Application for Amendment of Plan Under Section 12A of the Town Planning Ordinance (Cap. 131) to Rezone the Application Site from “Green Belt” and Area shown as ‘Road’ to “Residential (Group C)5” for Proposed Residential Development at Various Lots in D.D. 210 and Adjoining Government Land, Pak Wai, Sai Kung (Planning Application No. Y/SK-HC/8)

Submission of Further Information – Responses to Departmental Comments

Responses-to-Comments Table

Responses to Comments – Departmental Comments

SCALE	1:1500 @ A3	DATE	Jul 2025
CHECK	CC	DRAWN	LL
JOB No.	--	DRAWING No.	3-2
		REV	-

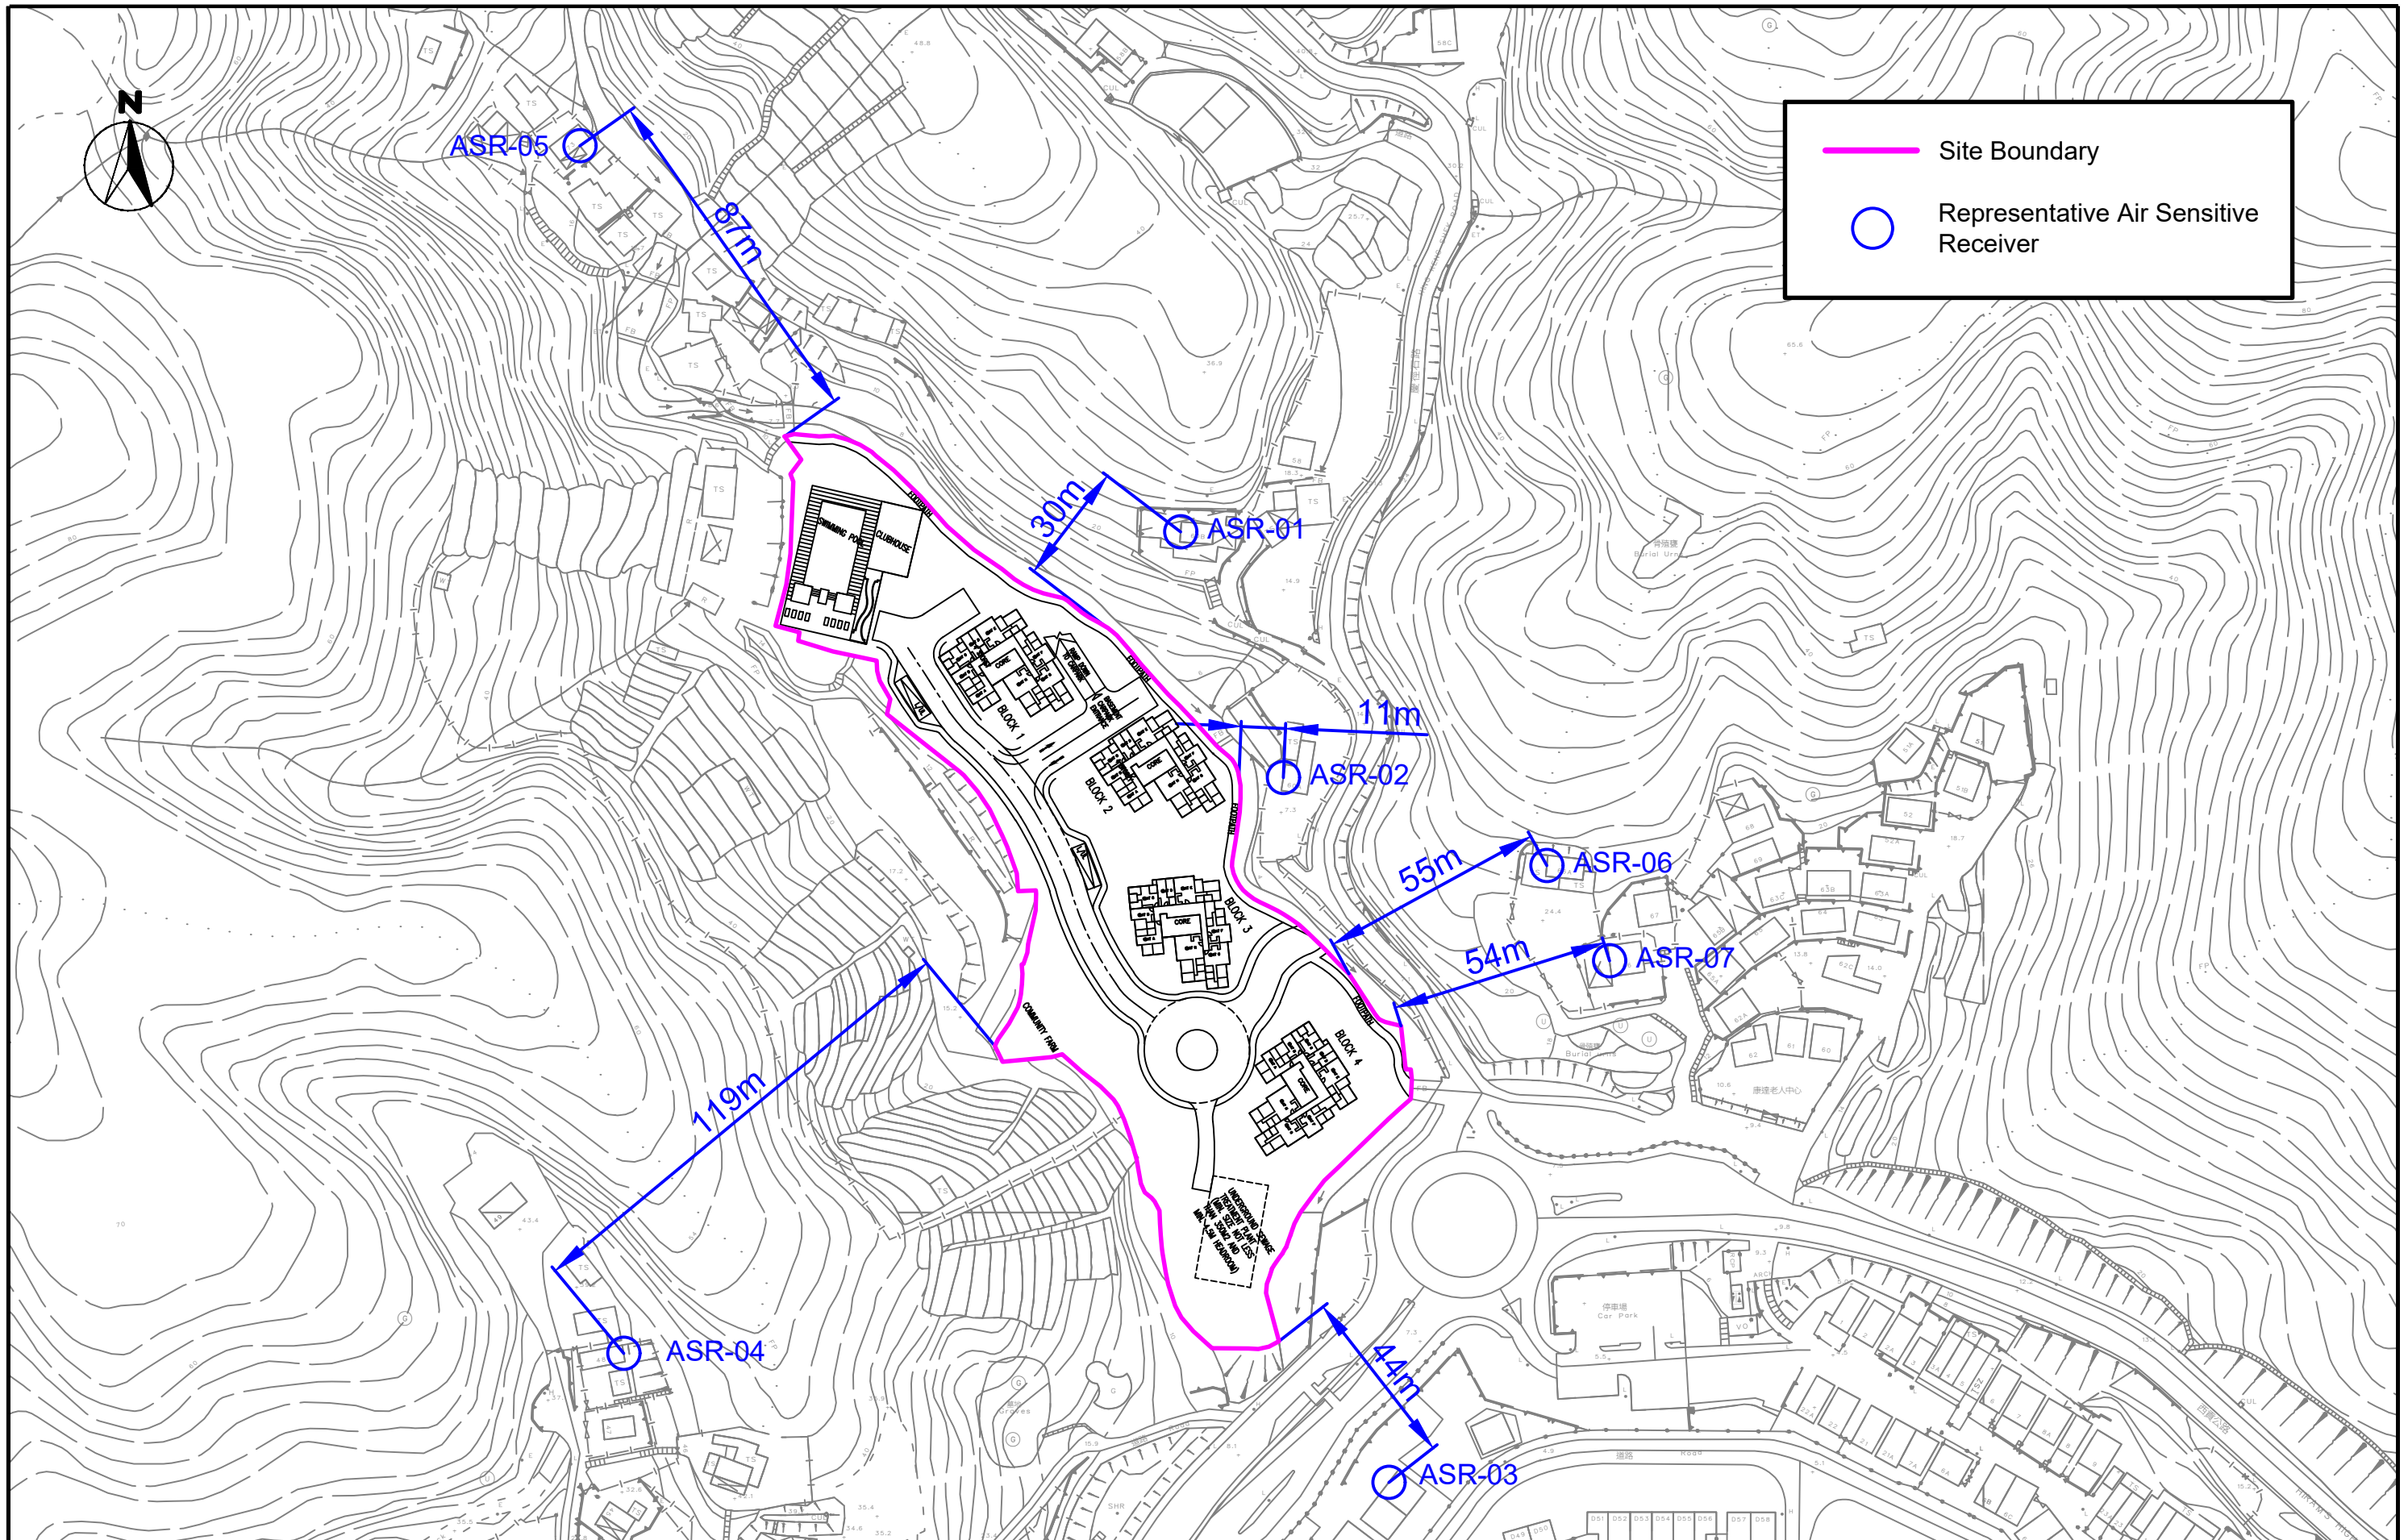
No.	Comments	Responses
	<p>b. Please identify representative ASRs at the east of Hing Keng Shek Road and north of Hiram’s Highway.</p> <p>20. Figure 3-2 – Please indicate PASR-01 to PASR-06 in the figure.</p> <p>21. Section 3.5 –</p> <p>a. Please provide more information including but not limited to: the size of the demolition, site formation or/and excavation area, amount of excavated materials to be handled, number of dump trucks and mechanical equipment to be used per time over the work site.</p> <p>b. Please supplement if there are any concurrent projects within 500m assessment area. If affirmative, please discuss cumulative constructional air quality impact.</p> <p>22. Section 3.6.1 – Please provide the separation distance between the STP and the nearest ASR of the proposed development. Please estimate the scale of the STP.</p> <p>23. Section 3.6.2 – Please indicate the location of carpark and carpark exhaust in a figure.</p> <p>24. Section 3.6.4 – While it is noted that the road type of Hing Keng Shek Road would be classified as rural road (RR), considering the traffic flow of the Hing King Shek Road and the associated potential road traffic</p>	<p>Additional representative ASRs (ASR-06, ASR-07) at the area at the Hing Keng Shek Road and north of Hiram’s Highway are identified. Table 3-6 and Figure 3-2 of the Revised EA have been updated accordingly.</p> <p>Figure 3-3 has been updated to include the ID of the planned ASR. Please refer to Figure 3-3 of the Revised EA.</p> <p>Section 3.5.2 and Table 3-8 have been supplemented and revised in the Revised EA to discuss the size of the construction works, maximum number of dump truck per day and the number of concurrent PME.</p> <p>Sections 3.5.3 to 3.5.6 and Table 3-9 have been supplemented to include the planned development and discuss the cumulative construction air quality impact. Please refer to the Sections 3.5.3 to 3.5.6 and Table 3-9 of the Revised EA.</p> <p>Section 3.6.1 and Figure 3-3 have been revised to include the separation distance and scale and indicate the separation distance respectively. Please refer to the revised Section 3.6.1 and Figure 3-3 of the Revised EA.</p> <p>The location of carpark is supplemented in Appendix 2-1 of the Revised EA.</p> <p>Please note the proposed development is still in early stage, the location of the carpark exhaust will be subject to detailed design stage. However, the carpark exhaust will be designed in accordance with ProPEDD PN2/96 and in a way that will not cause nuisance to occupants in the building or of neighbouring buildings, as stated in Section 3.6.2.</p> <p>Buffer distance of 10m for “District Distributor” has been adopted for the Hing Keng Shek Road.</p>

Buffer Region for Road Traffic Emission

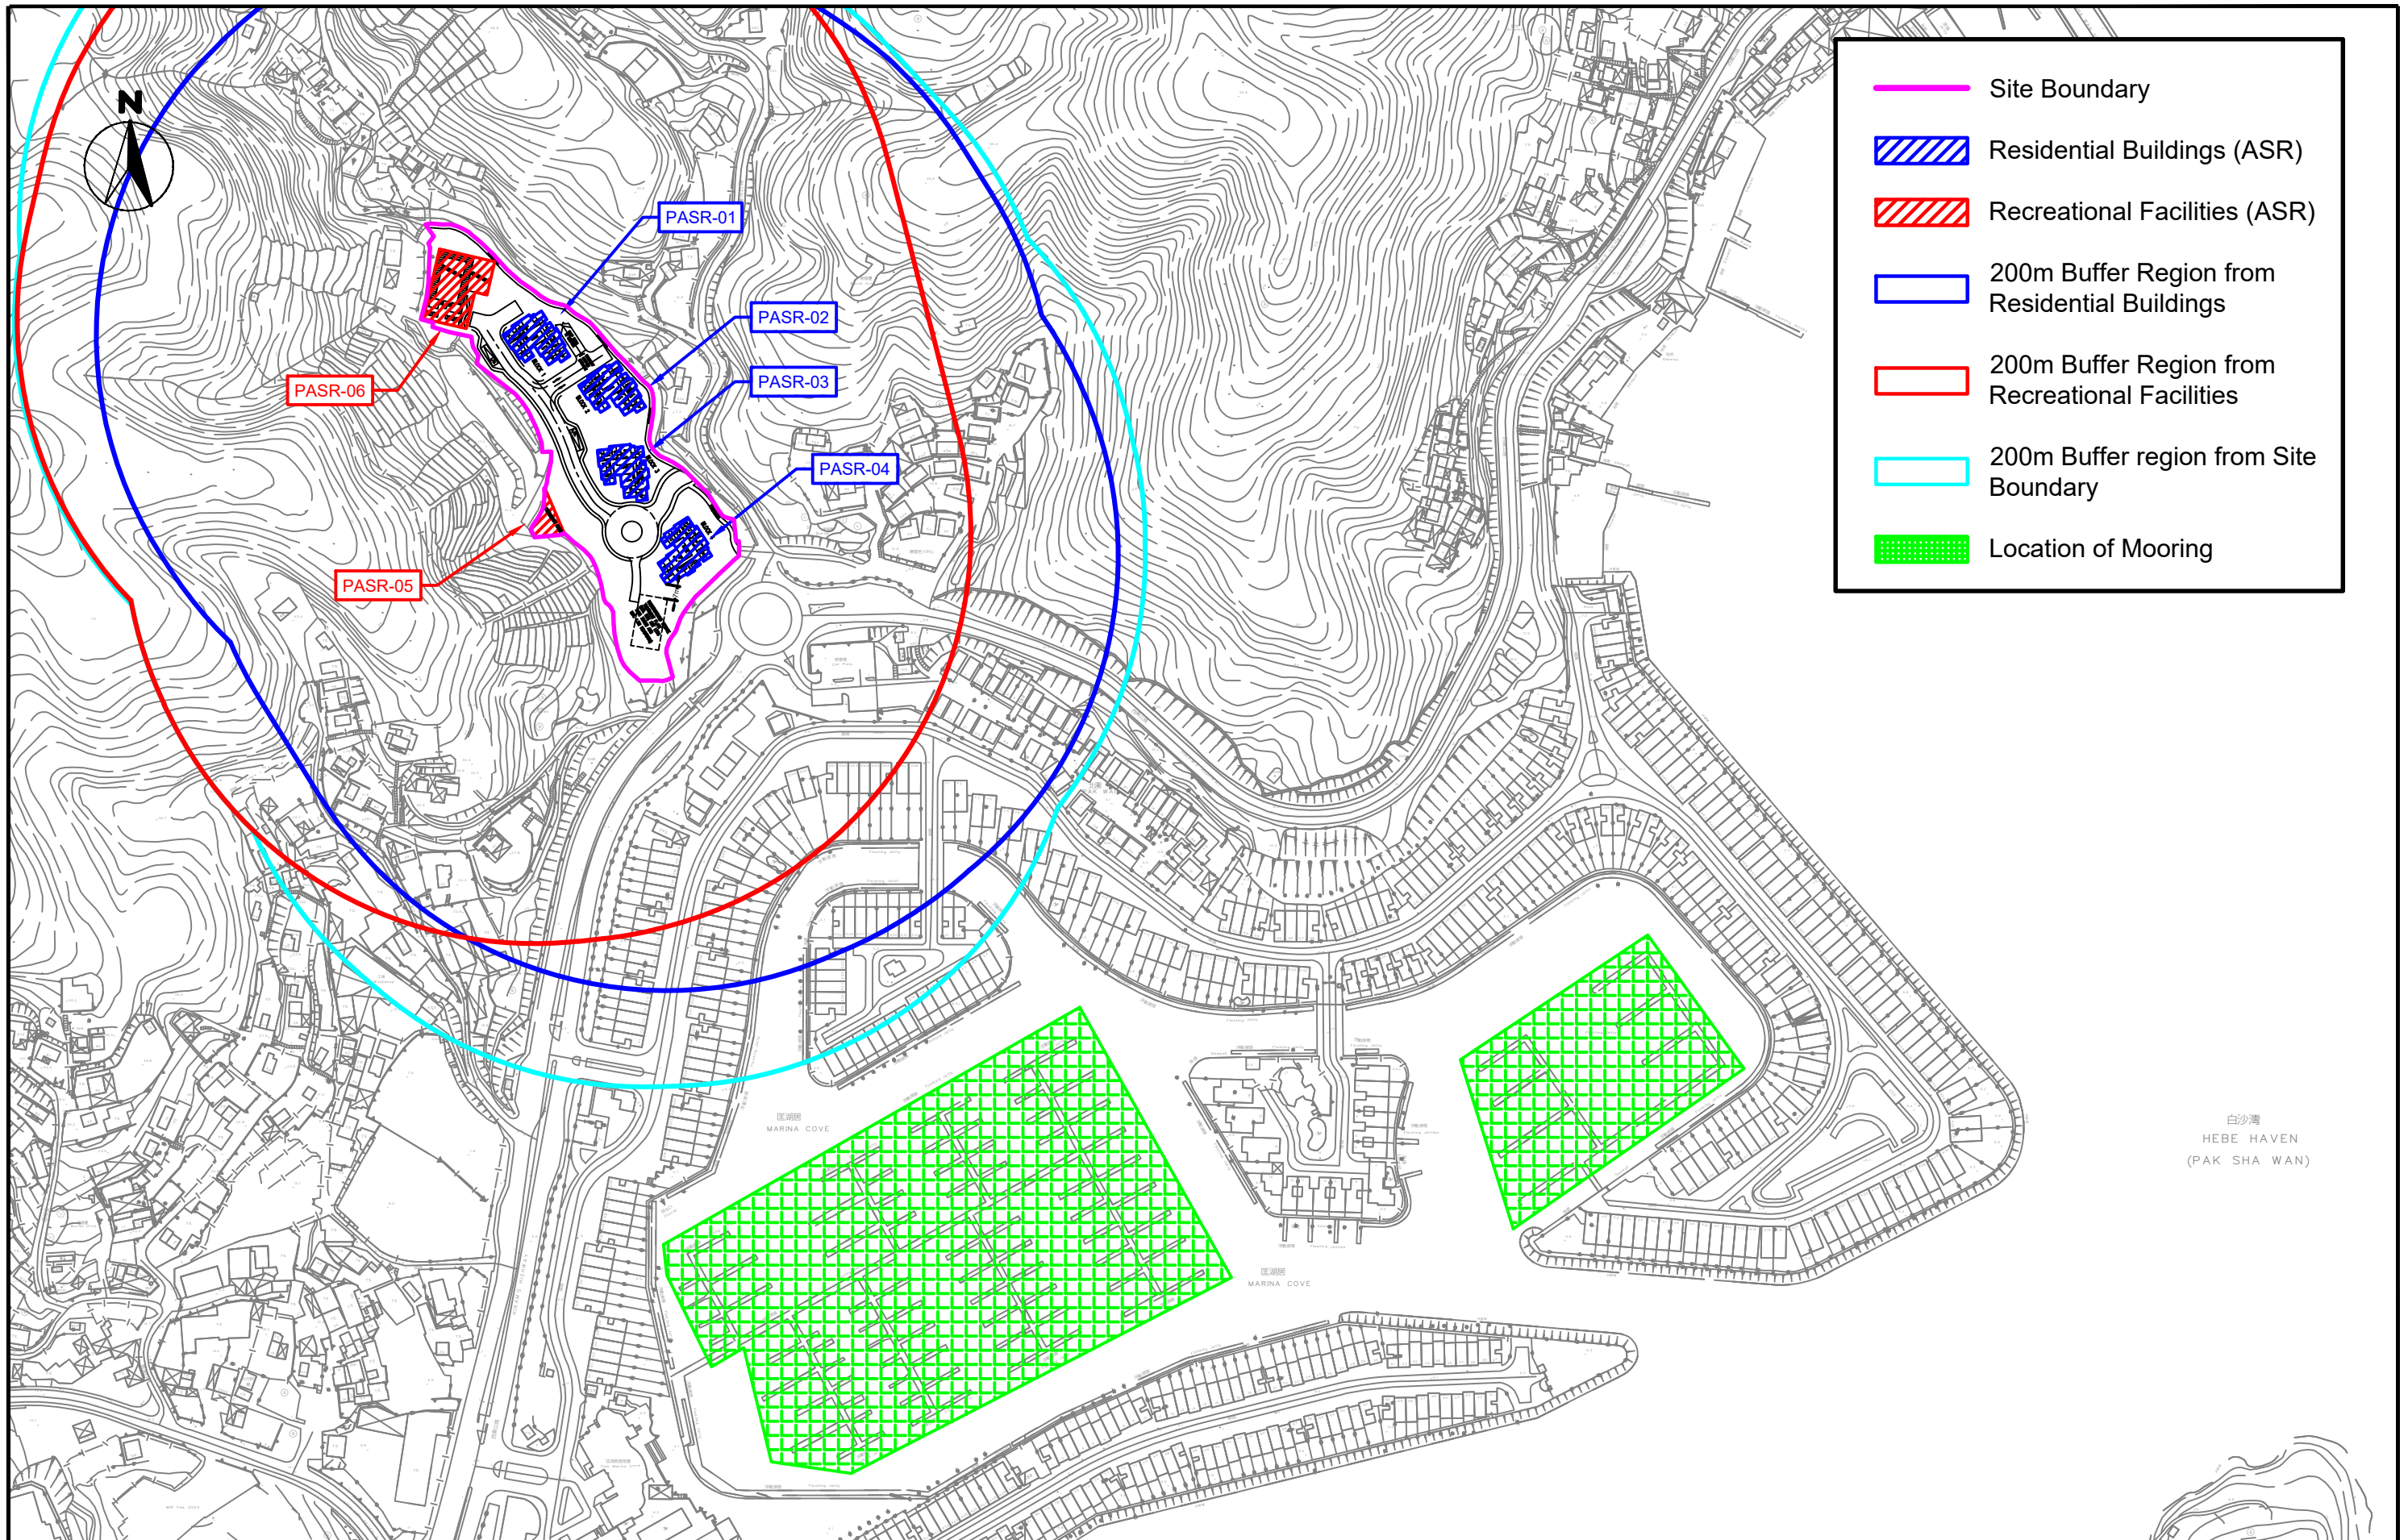
No.	Comments	Responses
	<p>impact air quality impact of RR could be comparable to district distributor (DD)/local distributor (LD), please review and confirm whether at least 10m buffer distance from the Hing Keng Shek Road to the nearest ASR/ air sensitive uses within the proposed development could be allowed as conservative approach. Otherwise, further justification on adopting the buffer distance of less than 10m shall be further supplemented to demonstrate the proposed development would not be subjected to potential adverse air quality impact.</p> <p>25. Section 3.6.6 – Please provide the dates of the site survey. Please state clearly that there is no chimney emission from the proposed development. Please be reminded that it should be the responsibility of the applicant and their consultant to ensure the validity of the chimney data by their own site surveys. Should the information of industrial chimneys be subsequently found to be incorrect, the assessment result as presented in the planning application would be invalidated.</p> <p>26. Please highlight all the changes/amendments in the next submission for review.</p>	<p>Please refer to Section 3.6.4 and Figure 3-5 of the Revised EA.</p> <p>Section 3.6.6 has been updated in the Revised EA to clearly state that no chimney will be proposed in the proposed development.</p> <p>The date of site survey is also supplemented in Section 3.6.6.</p> <p>Noted. All changes are highlighted in yellow for ease of review and checking.</p>

- 3.6.5 The building footprint of the Proposed Development and the buffer regions for road traffic emission are indicated in Figure 3-5. Although the layouts are tentative and subject to change, no significant change in building footprint is anticipated. As the building footprint are clearly outside of the required buffer regions, no adverse air quality impact arising from the nearby traffic emission is anticipated.
